Dec. 04,2025

MCBQ*3、MC(K)QI3、MCQV3(L)、MGT* Series Specification Change Notification

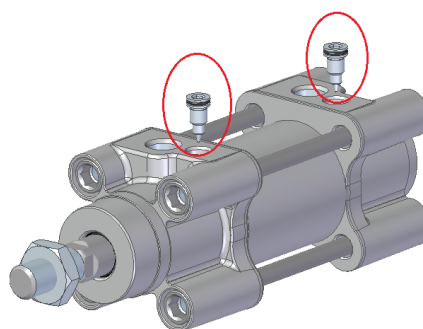
Due to adjustments in the product strategy, the needle valve material has been changed.

Before	After
Needle Valve Material: Brass	Needle Valve Material: Resin Add needle valve tightening torque data Ø32~ Ø63 : 2~2.5 kgf-cm Ø80~ Ø100: 4~4.5 kgf-cm
Needle Valve locations are as indicated (circled) in the figure.
